**TRANSNUCLEAR, INC.**

E-17906

Subject: TN-68 Transport SAR Responses to RAI1  
Docket 71-9293, TAC No. L22899

Enclosed please find the responses to RAI#1 on the TN-68 Transport SAR. Also enclosed are the following revisions to the SAR which have been marked Rev. 1:

**Figure 2-1**  
**Finite Element Model**

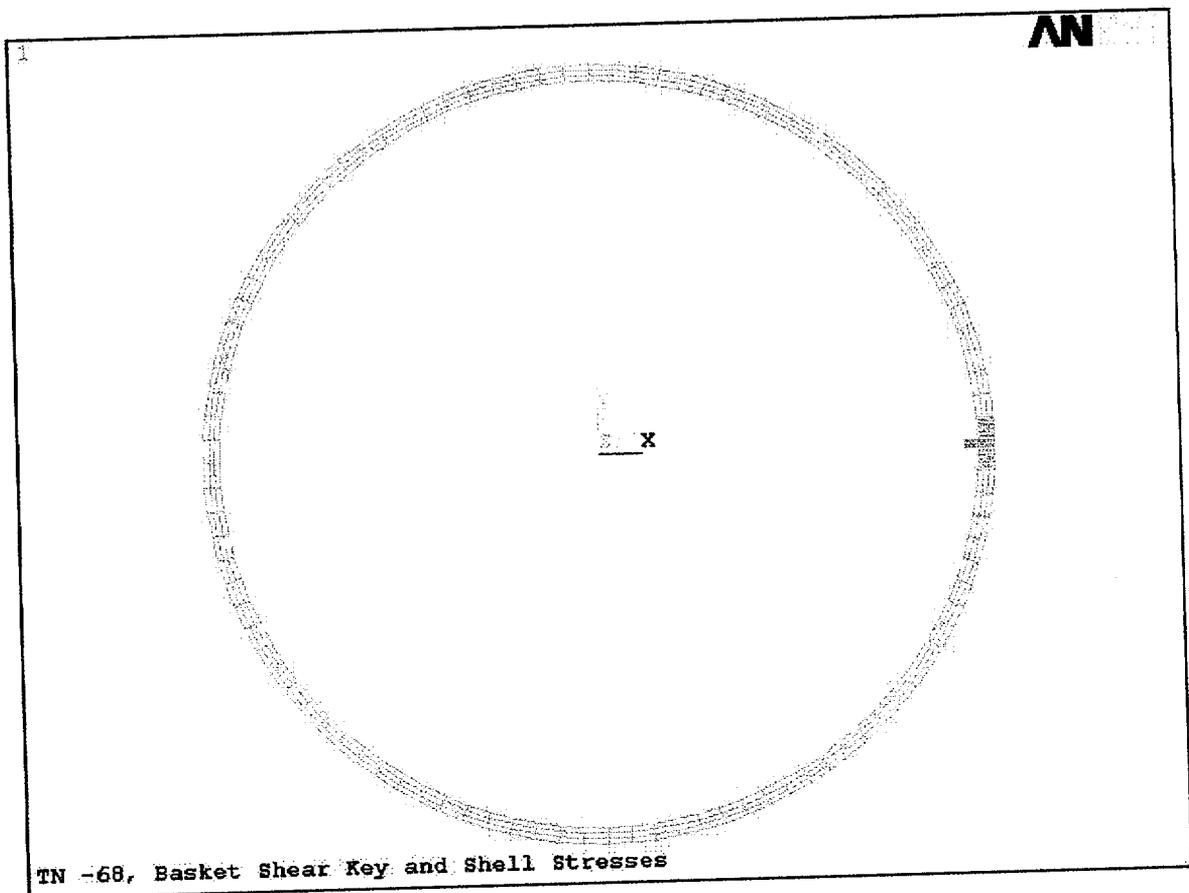
- 2-6 Evaluate the structural adequacy of the shear key (Part No. 40 on Drawing No. 972-71-6) during the 30-foot drop tests.

The purpose of the shear key is to prevent the basket assembly from rotating freely inside the cask. Structural details of the shear key and attachment details to the containment vessel are not provided on the package certification drawings (see related RAI 1-3.) During a 30-foot drop onto the side of the package, it is possible that the shear key will be loaded transversely. Depending on the attachment detail, this could adversely load the containment shell.

**Response:** The shear key is attached to the containment shell using a 0.25” partial penetration plus a 0.06” fillet weld on both sides of the 0.75” thick key. TN drawing no. 972-71-6 has been revised to show the weld details and is included with this response. The structural analysis of the shear key is provided below.

A two-dimensional finite element model of the shear key and containment cylinder was constructed using Plane 42, 2-D structural solid (with thickness option) elements. The mesh size in the model was determined from two basic considerations, namely, (1) proximity to the point (or line) of impact and (2) the level of stress anticipated at the location. The portion of the cylinder away from shear key intersection was modeled with a coarser mesh than that near the

intersection. The finite element model is shown in Figure 2-1 of this RAI. There are separate nodes at weld locations between the key and containment shell, the partial penetration welds are simulated by coupling the nodes (both x and y directions) at the weld locations. The fillet welds are not included in the model. This is conservative, since the fillet welds will increase the weld area and reduce stress. Figure 2-2 shows this constraint detail.

**“Hot” Fuel Assembly, Normal Conditions of Transport**

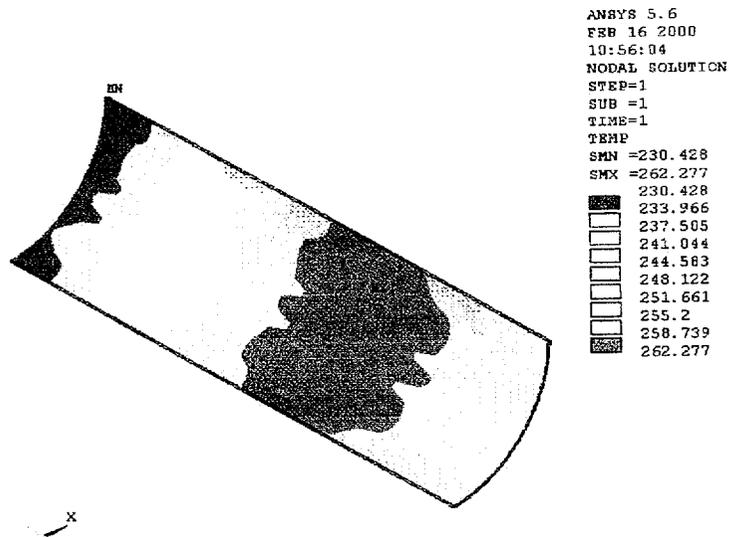
- 3-7 Provide the axial temperature profile of: (1) the hot assembly and (2) the cask inside wall for normal conditions of transport.

The packaging and contents must be described in sufficient detail to provide an adequate basis for its evaluation (10 CFR 71.33.)

**15° Drop Configuration, Finite Element Model**

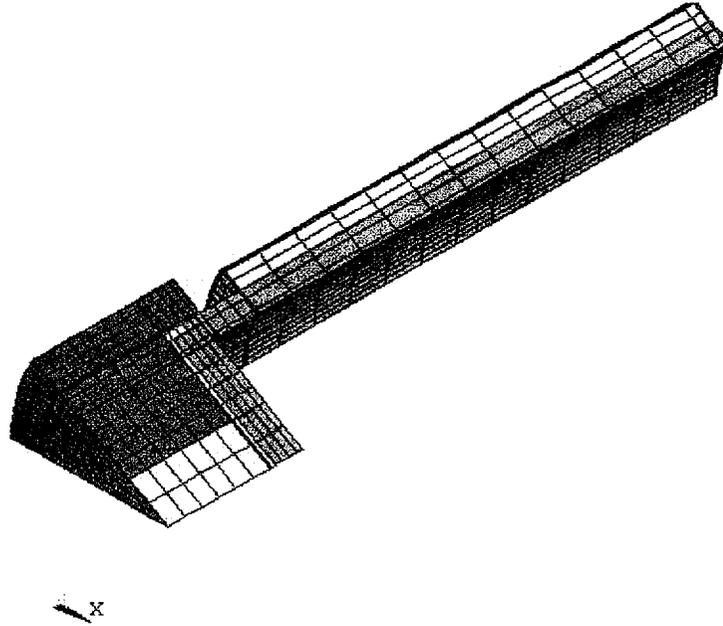
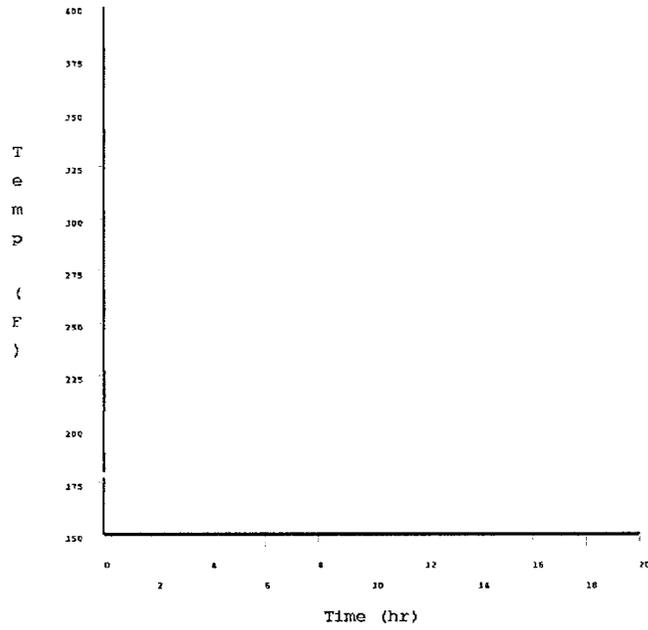
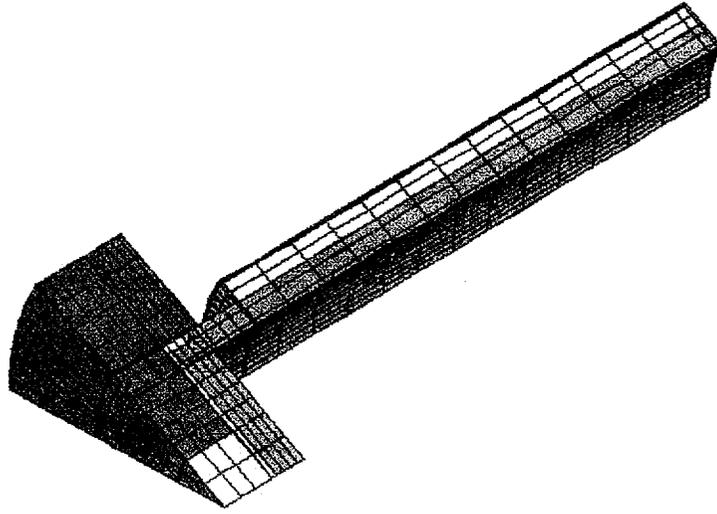
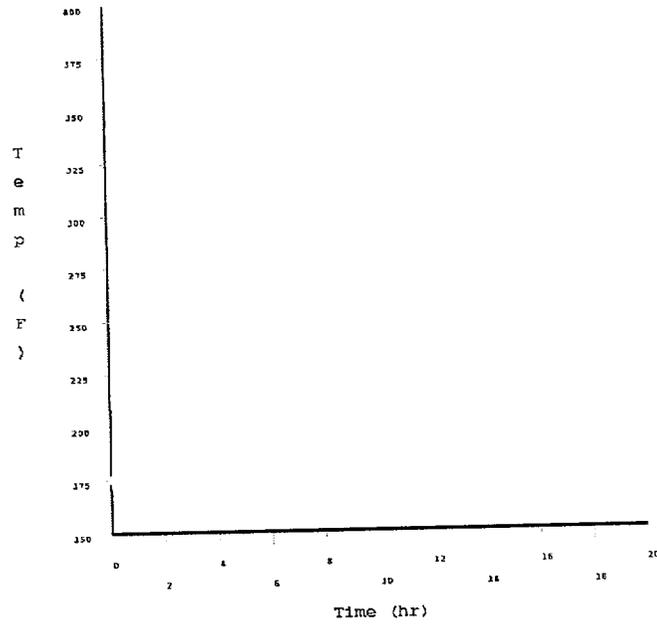
- 3-8 Revise the application to show that the maximum seal temperatures are within allowable limits under fire test conditions, considering impact limiter damage from the sequential 30-foot and 40-inch puncture tests.

The SAR evaluation calculates seal temperatures without considering the extent to which the impact limiter wood may be charred or no longer present in the crushed areas and where the puncture pin may penetrate the impact limiter. See related RAI 2-7.

Plots of the finite element models and the transient seal temperatures for each of the crush configurations are shown below. The analysis demonstrates that the peak transient seal temperatures remain below 375 °F.

**Temperature Distribution, End of Fire Condition**

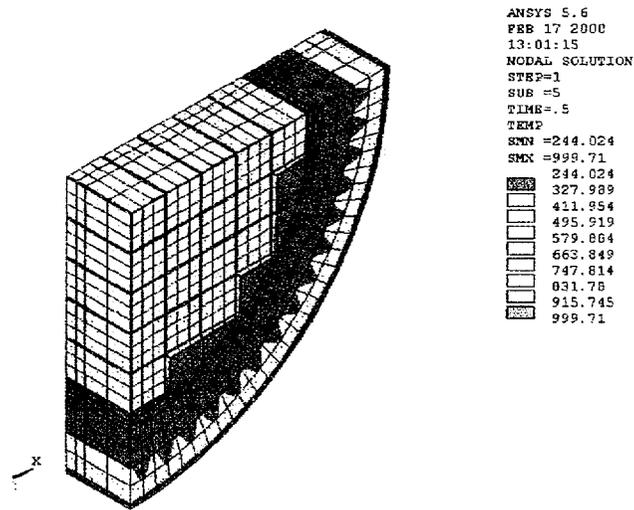
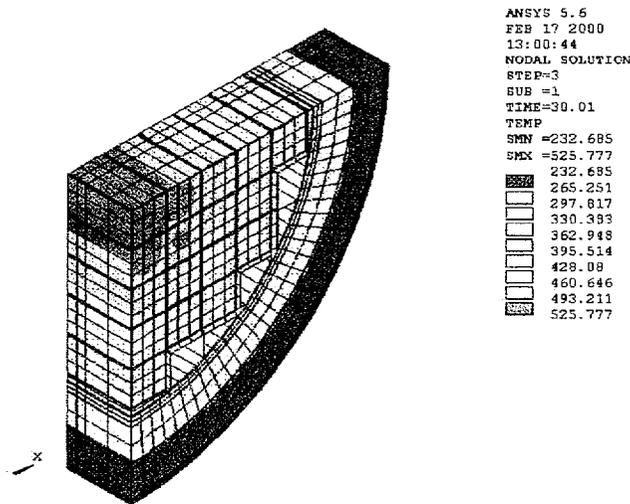
3-9-1 Provide figures representing the cross section model and calculated temperature distributions for the fire transient at the end of the fire and after equilibrium is established in the post fire phase.

**Response:** The application will be revised using a post fire absorptivity of unity. (see response to RAI 3-9-3) The requested figures, using the revised absorptivity, are shown below:

**Cask Inner Shell @ time = 2.3 hours**

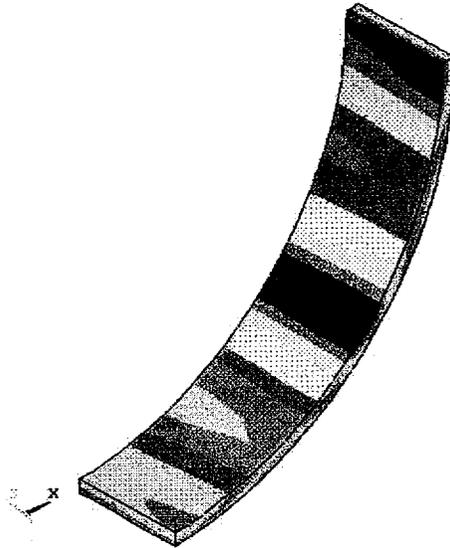
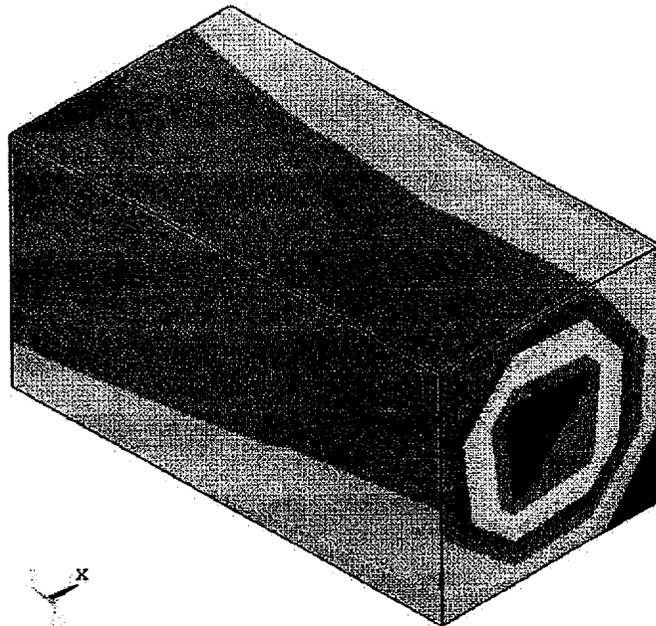
3-9-2 Provide the axial temperature profile of:

(A) the cask inside wall at time = 2.3 hours and

The application will be revised using a post fire absorptivity of unity. (See response to RAI 3-9-3) Provided below are temperature distributions of the cask inner shell and the hot assembly, taken from the cross-section model, when they reach their peak transient temperatures.
